DRAFT
MAP Series of PWR Shipping Packages
Amendment to Certificate of Compliance
USA/9319/B(U)F-96
Docket 71-9319

June 9, 2009
Rockville, MD

Revised Licensing Documents

Drawing 9045402 Revision 1

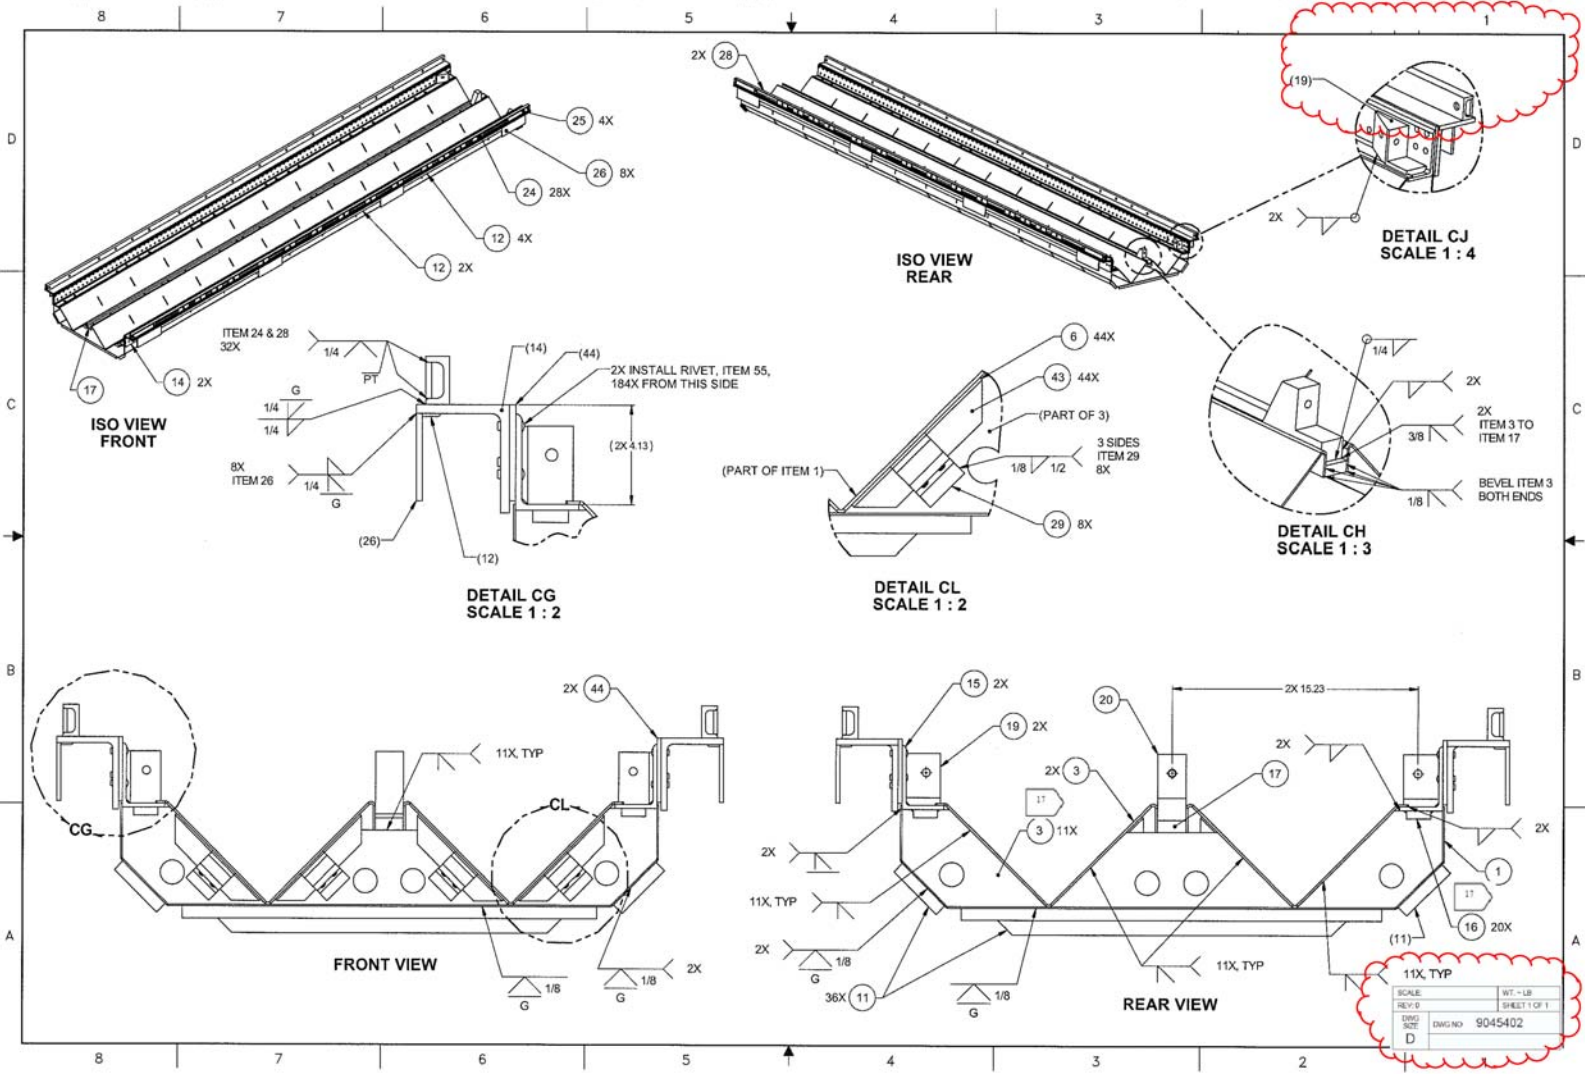
- ◆ ***Recreated in CAD system***

- ◆ ***Format change only for future revisions***

No impact regarding the performance of the container under accident conditions.

Drawing 9045403 Revision 1

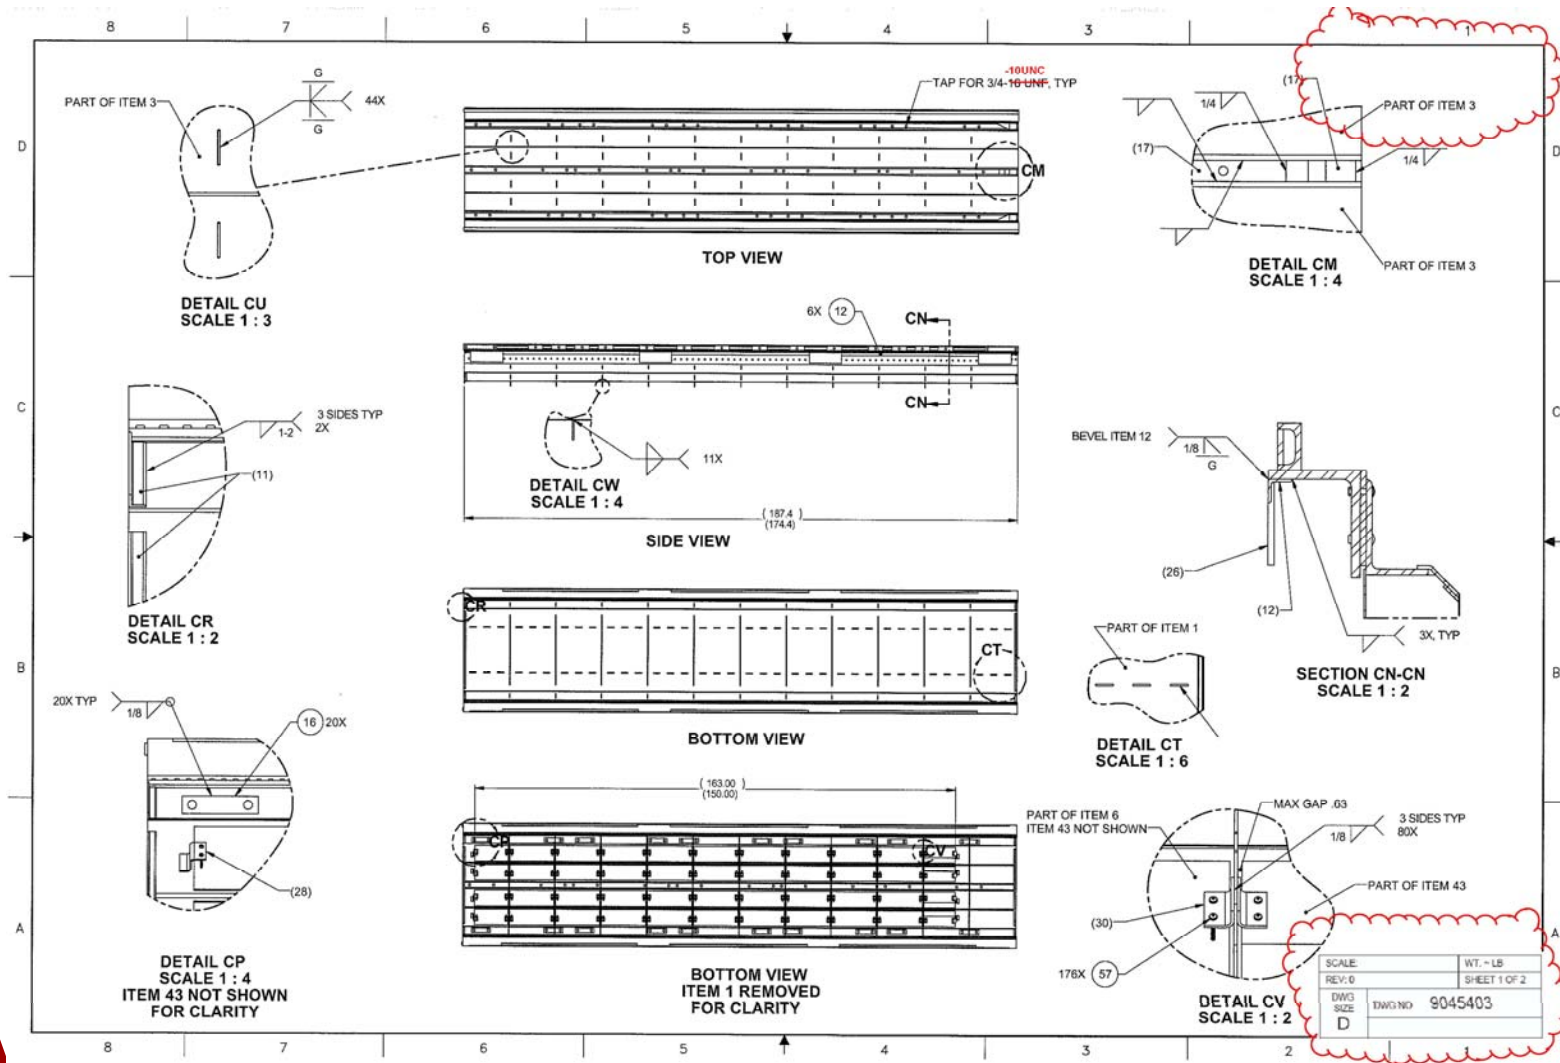
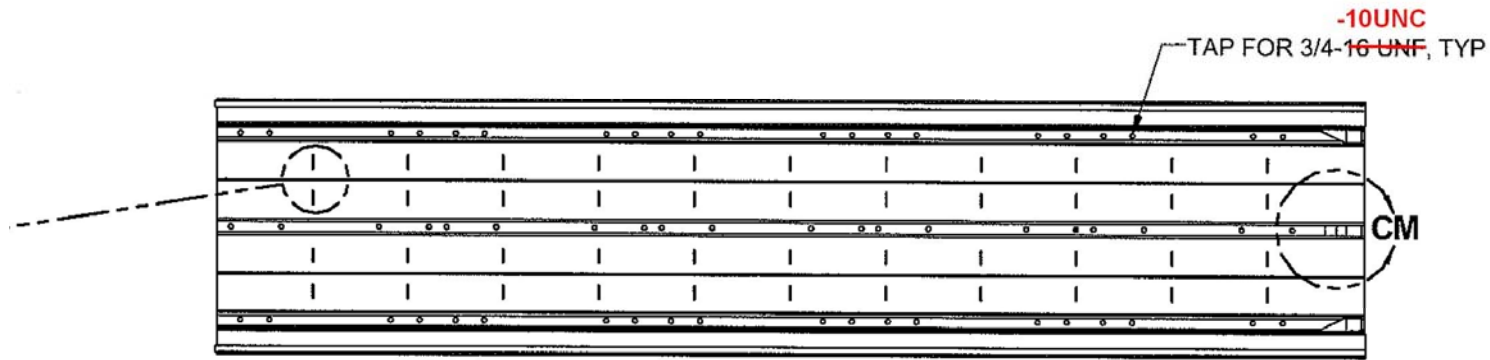
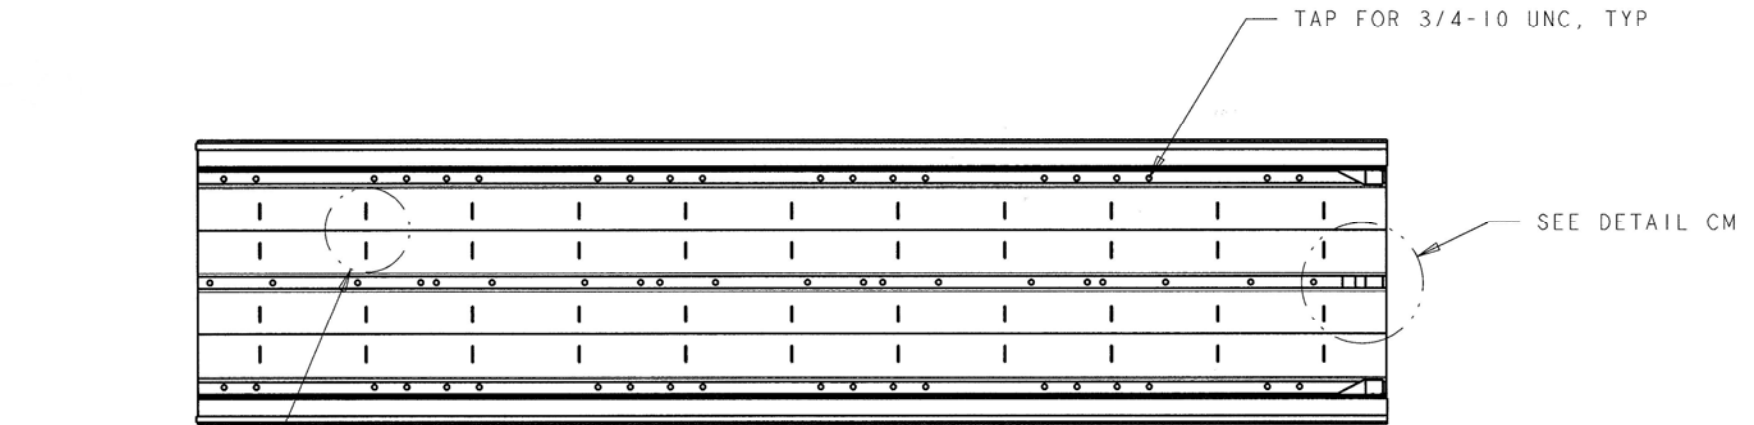
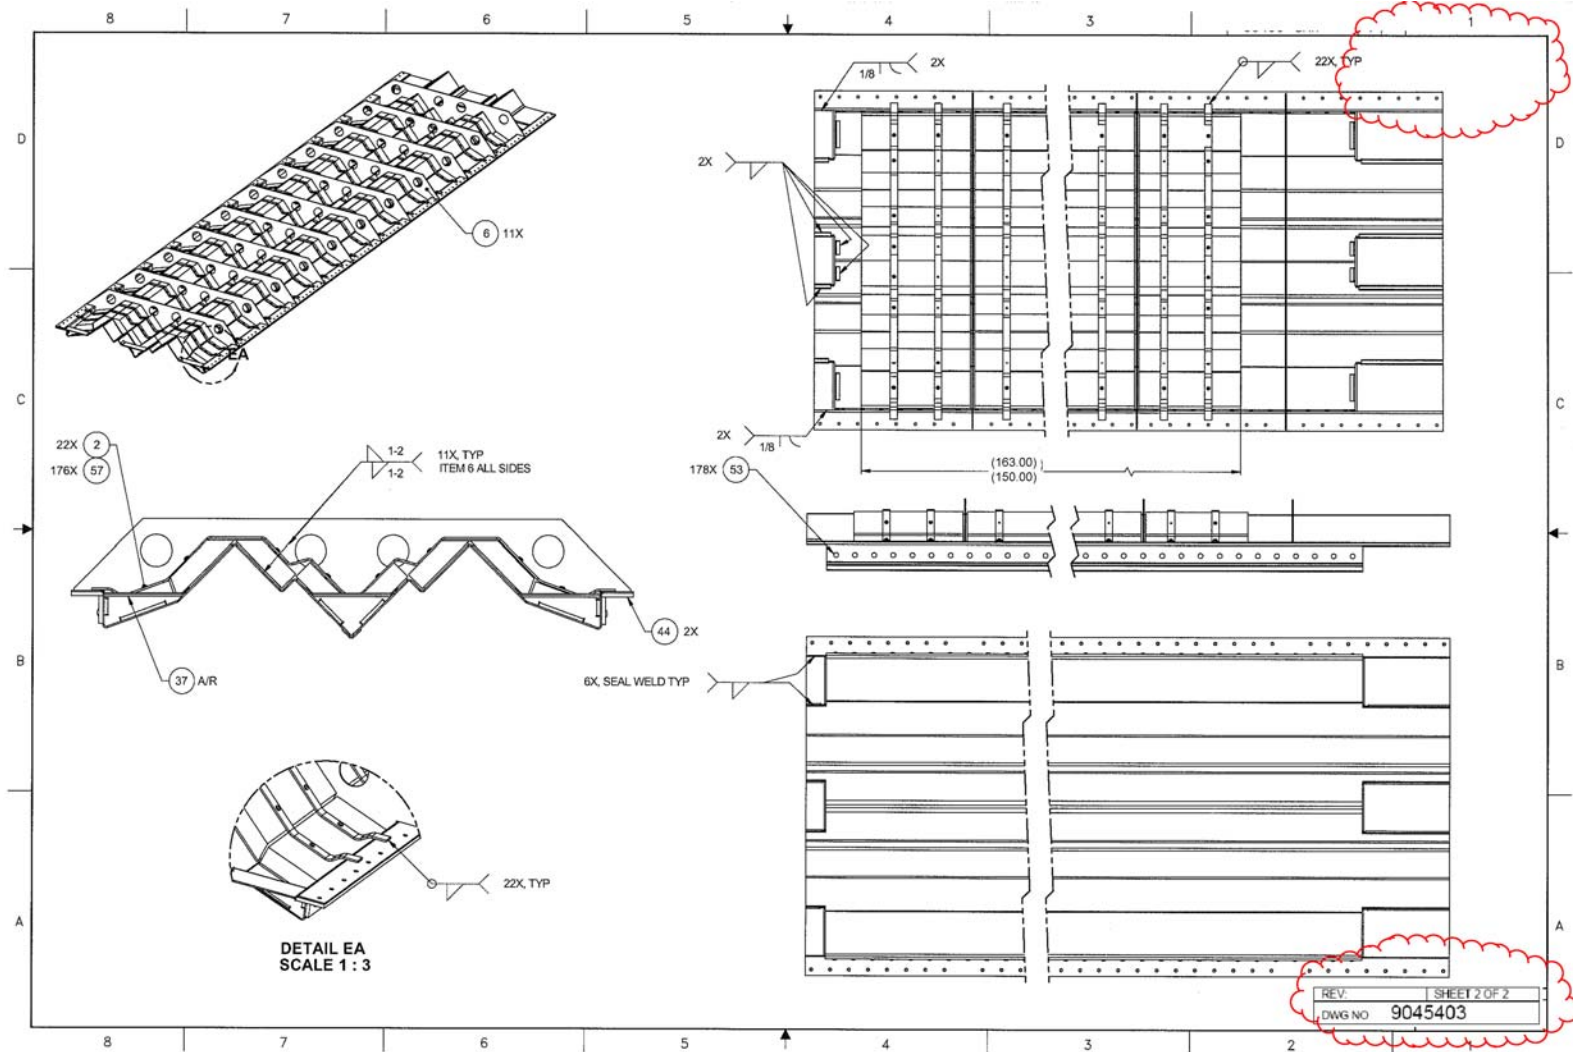
- ◆ ***Recreated in CAD system***
- ◆ ***Changed tapped holes from -16 UNF to -10 UNC***

- ◆ ***Format change for future revisions***

No impact regarding the performance of the container under accident conditions.
